SERVICE BULLETIN

APPLICABILITY: 2015MY Legacy, Outback, Impreza, XV Crosstrek and WRX Models with Fujitsu-Ten (F10) 7” Display Audio Systems (without navigation)

NUMBER: 15-183-15R
DATE: 06/17/15
REVISED: 05/02/16

SUBJECT: Procedures for Updating the Head Unit Operating Software

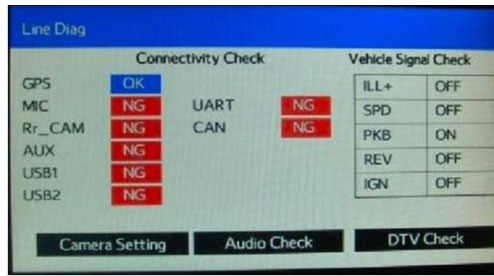
- **Symptom 1:** Audio output is lost after a few minutes when listening to Sirius/XM satellite radio.
Change: Logic update to provide proper Sirius/XM satellite radio operation.
- **Symptom 2:** Bluetooth feature becomes inoperative.
Change: Logic update to provide proper Bluetooth feature operation.
- **Symptom 3:** HD Radio “freezes” after a few minutes of play.
Change: Logic update to provide proper Sirius/XM satellite radio operation.
- **Symptom 4:** Back-Up Camera “help lines” do not appear.
Change: Logic change to have the assist lines appear 8 seconds from engine start.
- **Symptom 5:** Incorrect Umlaut characters are shown on StarLink display.
Change: Logic change to allow proper display of Umlaut letters.

List of incorrect Umlaut letters is shown in yellow.

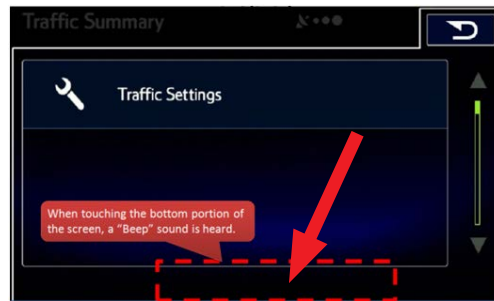
- **Symptom 7:** Back-Up Camera is displayed with shifter in positions other than Reverse.

Change: Logic change to allow display with shifter in Reverse only.

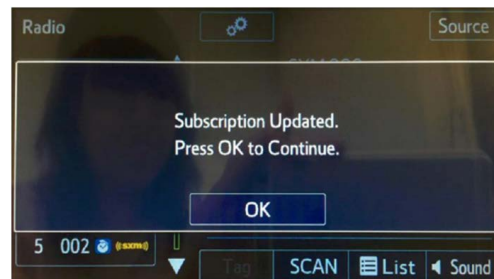
- **Symptom 10:** “Beep” sound heard when touching the bottom of the display screen where no function soft touch keys are displayed.

Change: Logic change to eliminate beeping sound from inactive soft touch key screen areas.
